STAFF REPORT
COMMUNITY DEVELOPMENT DEPARTMENT

HEARING DATE: June 6, 2024
 TO: Planning & Zoning Commission
 FROM: Stacy Hersh, Associate Planner
 208-884-5533
 SUBJECT: The Gateway at Ten Mile PP, CUP
[H-2024-0010](#)
 LOCATION: NEC of W. Franklin Rd. & N. Ten Mile Rd., in the West ½ of the SW ¼ of Section 11, Township 3N., Range 1W. (Parcel: S1211336065)

Preliminary plat (PP) consisting of 31 buildable lots 3 common lots on 38.99+/- acres of land zoned C-G and R-40 for The Gateway at Ten Mile; and a Conditional use permit (CUP) for a multi-family development containing a total of 390 residential dwelling units in the R-40 zoning district.

A. Preliminary Plat (date: 03/11/2024)

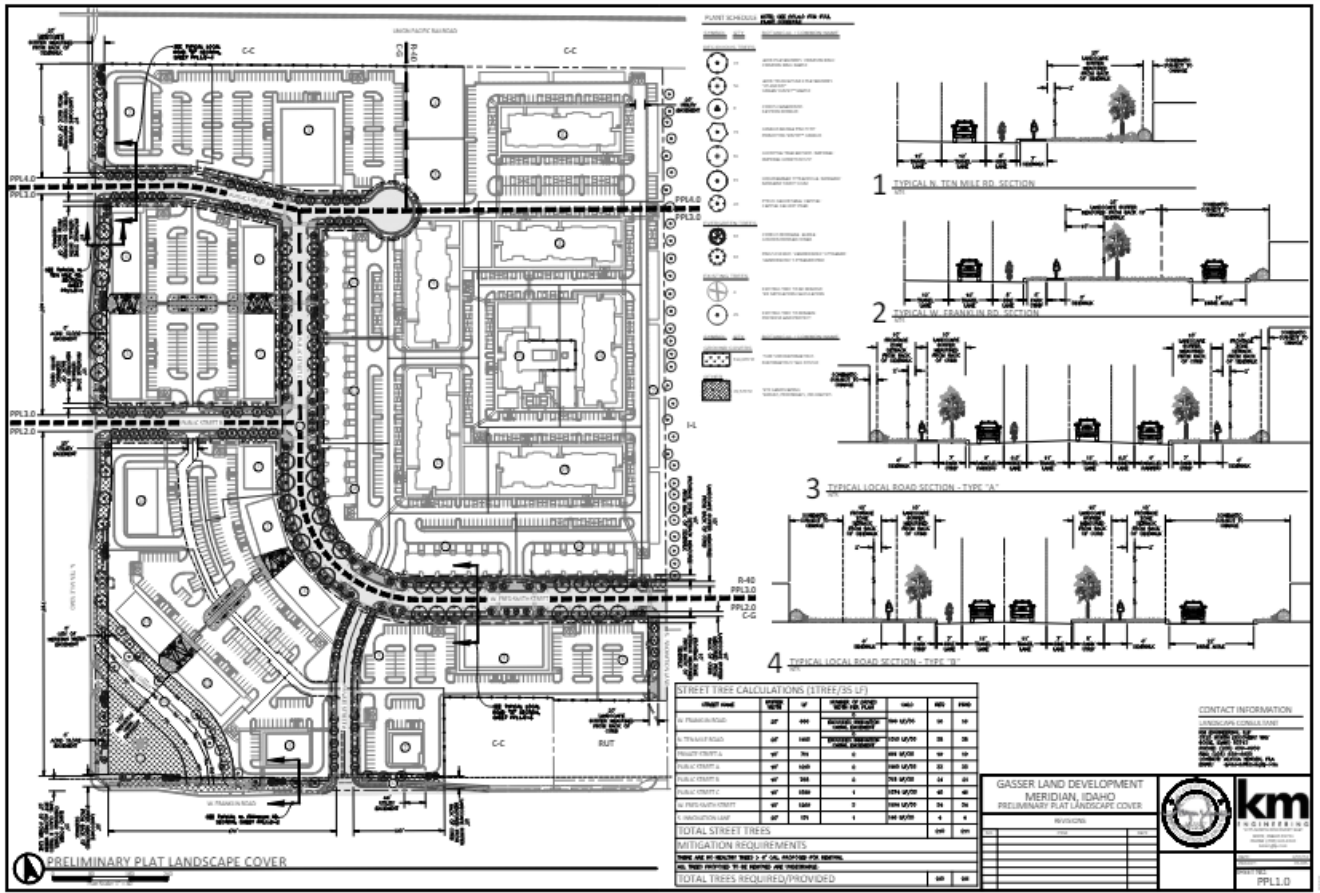
Access is proposed via three roads: W. Franklin Rd., a commercial arterial; N. Ten Mile Rd., a residential mobility arterial; and the future extension of N. Wayfinder Avenue, a towncenter collector street designated as N. Innovation Lane on the plat. However, the Applicant inaccurately labeled the collector street as S. Innovation Lane on the plat, whereas S. Innovation Lane is located farther west across Franklin Road and functions as a local street. South Wayfinder Avenue lines up directly to the development's south across Franklin Road. **Staff recommends that the Applicant correct the name of the future collector street on the plat.**

with Private Street A. Staff recommends depicting Private Street A as a drive aisle on the plat because it does not meet the private street standards outlined in UDC 11-3F-4.

The Applicant proposes extending W. Fred Smith Street from east to west, then turning into Public Street C heading north. *The Applicant should connect into Fred Smith Street from the east and construct Street C and Fred Smith Street as a 36-foot wide local commercial street sections with 2-travel lanes, parking on both sides of the roadway, vertical curb, gutter, and bulb-outs at intersections and pedestrian crossings with an 8-foot planter strip and 10-foot wide multi-use pathways on both sides of the roadway.*

The Applicant proposes constructing Public Street A to run east-west along the northwest portion of this site, ending at the southwest corner of the proposed future Civic site, as required by the Development Agreement (#2021-082775). *The Applicant should construct Street A between Ten Mile Road and Street C as a 36-foot wide street section with 2-travel lanes, , vertical curb, gutter, an 8-foot wide landscape strip, and 10-foot wide detached concrete sidewalk.*

The Applicant proposes to construct a portion of Wayfinder Avenue to the site’s east property line. *The Applicant should construct a temporary cul-de-sac turnaround at the terminus of Wayfinder Avenue with a minimum of a 50-foot paved turning radius in accordance with ACHD’s conditions of approval.*

- b. The extension of N. Wayfinder Avenue on the east property boundary shall be included in the construction drawings for the first phase of development; or, may be included in a separate submittal to ACHD. **Replace S. Innovation lane with N. Wayfinder Avenue on the plat.*

- h. Remove Public Street B from the plat limiting the number of access points on a busy arterial street near the intersection per UDC 11-3A-3.
 - i. Depict a cross-access easement on Lots 3 – 9, Block 3 for the right-in/right-out drive aisle on the plat.

sides of the roadway, vertical curb, gutter, and bulb-outs at intersections and pedestrian crossings with an 8-foot planter strip and 10-foot wide multi-use pathways on both sides of the roadway on the plat.

- l. Lot 11, Block 3 shall remain preserved to relocate an ACHD pond and/or coordinate with the Meridian Parks Department to determine a future plan for the lot in accordance with DA provision 5.1n.

- m. Lot 10, Block 3 shall remain preserved for the Ten Mile Creek and associated easement.
 - n. Add a note to the plat requiring cross-access for all lots that do not have access to a public street.

B. Landscape Plan (date: 03/11/2024)

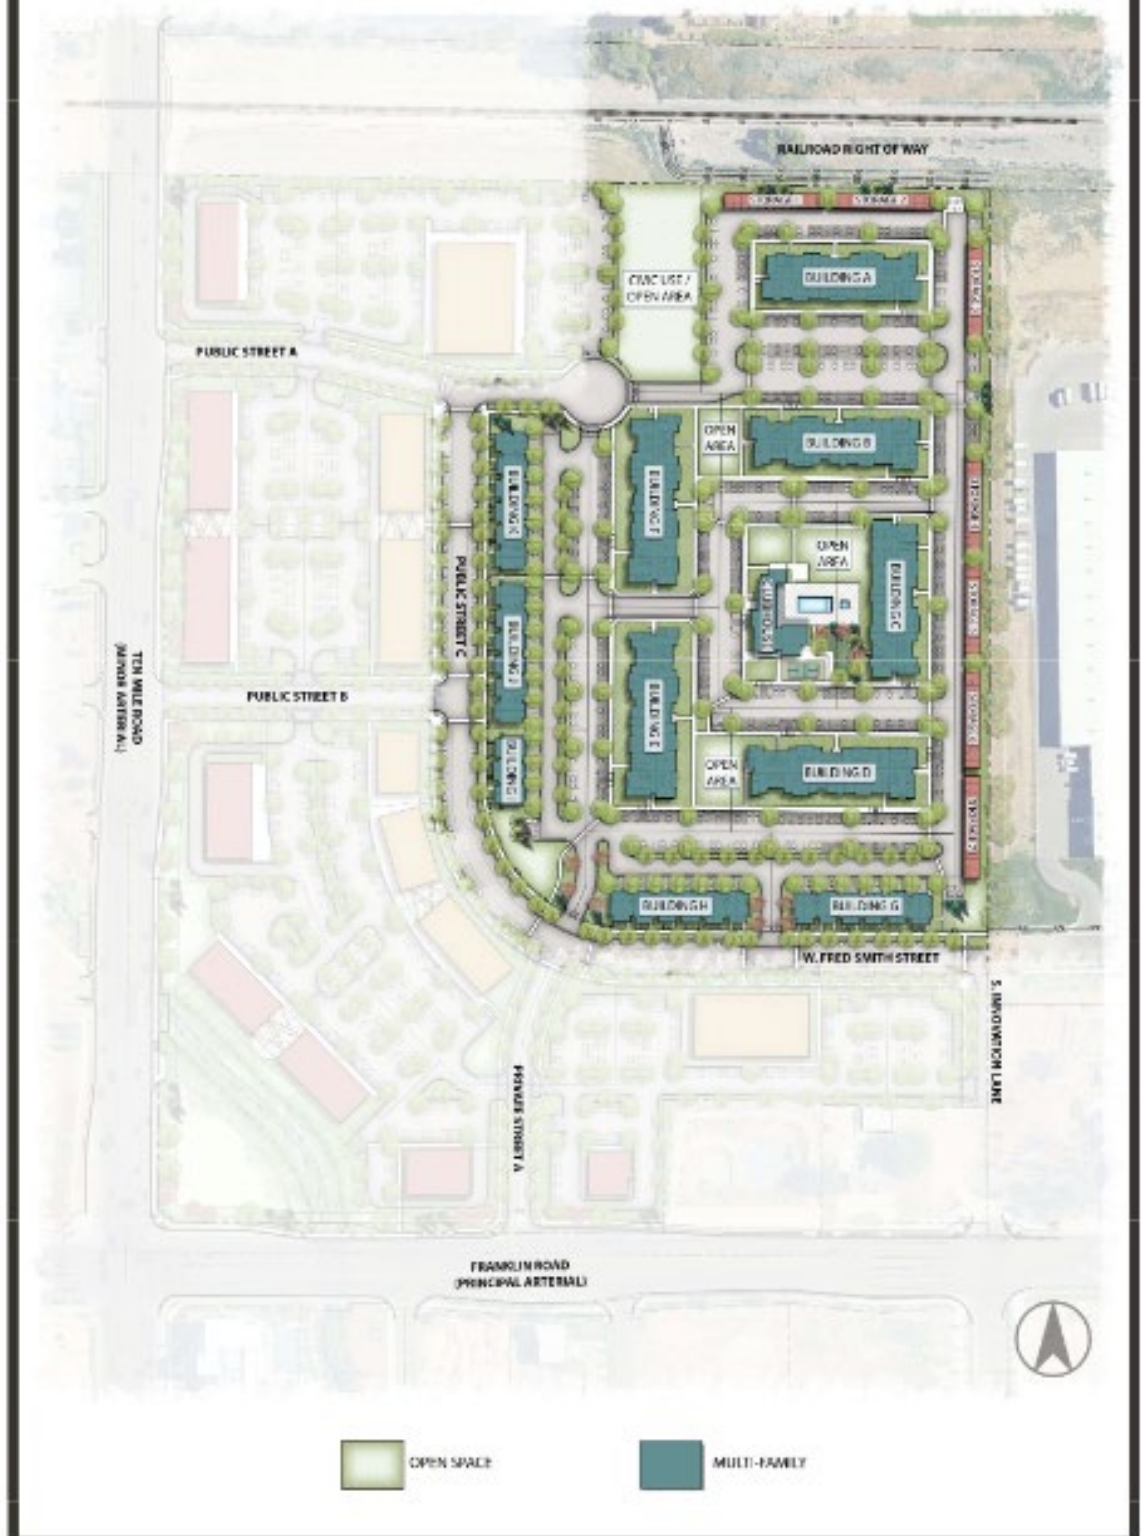
The number of trees proposed in buffers meets the minimum standard required by UDC 11-3B-7; however, the TMISAP requires an enhanced street buffer to align with the TM Center Subdivision directly to the south. (refer to figure below). Furthermore, Staff finds that the Applicant should enhance the landscaping around the Ten Mile Creek on Lot 10, Block 3 to create an attractive linear open space for the development.

A calculations table is included on the landscape plan submitted with this application demonstrating compliance with the above standards; however, Staff recommends that the applicant enhance the street buffers in accordance with the TMISAP guidelines (pages 3-26, 3-27, 3-28, 3-29 & 3-30.

- b. Include a detail of the proposed fencing at the time of CZC submittal.
 - c. Depict a minimum 5-foot wide detached sidewalk along S. Ten Mile Rd. in accord with UDC [11-3A-17A](#).

E. Site Plan For Multi-Family Portion Of Development (date: 03/11/2024)

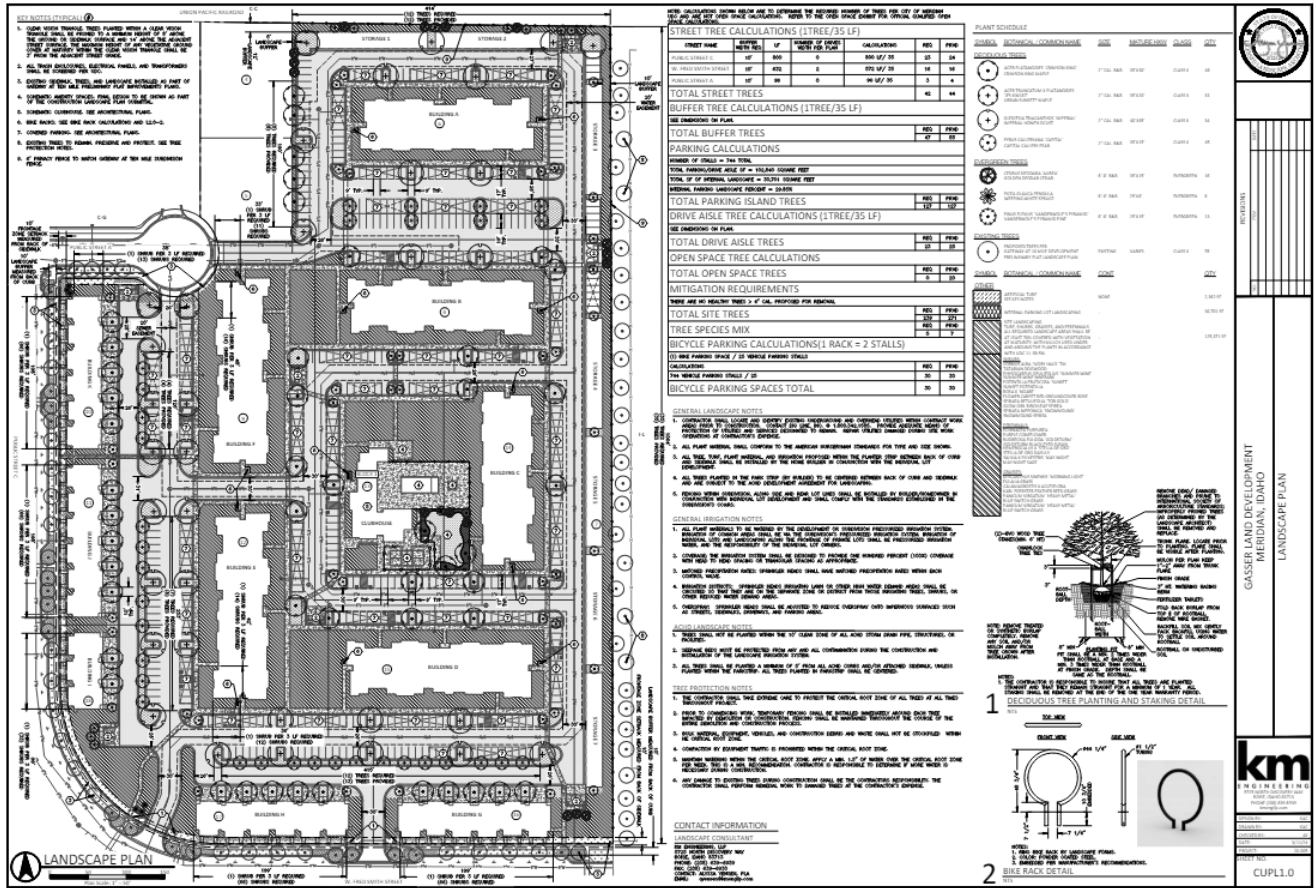
- c. A central mailbox location, including provisions for parcel mail, that provides safe pedestrian and/or vehicular access. *Located in clubhouse*
 - d. A directory and map of the development at an entrance or convenient location for those entering the development. *Depict on site plan*

The site plan submitted with the Certificate of Zoning Compliance application should depict the location of these items in accord with this standard.

All amenities are located within the central open space lot. The Applicant is proposing multiple amenities from the “Quality of Life” category, and missing an amenity from the “Open Space” category. The Applicant should add a picnic area that includes tables, benches, and a structure for shade in one of the open space grassy areas to meet the requirements of UDC Code 11-4-3-27.D for the site. Overall, the proposed amenities satisfy the required standards.

9. The multi-family development shall have an ongoing obligation to comply with the specific use standards listed in UDC 11-4-3-27.
10. Add a picnic area that includes tables, benches, and a structure for shade in one of the open space grassy areas to meet the requirements of UDC Code 11-4-3-27.D for the site at the time of CZC submittal.

- a. Depict the locations of the property management office, maintenance storage area, central mailbox location (including provisions for parcel mail, that provide safe pedestrian and/or vehicular access), and a directory and map of the development at an entrance or convenient location for those entering the development in accord with UDC 11-4-3-27B.7.

- d. Add a picnic area that includes tables, benches, and a structure for shade in one of the open space grassy areas to meet the requirements of UDC Code 11-4-3-27.D for the site at the time of CZC submittal.
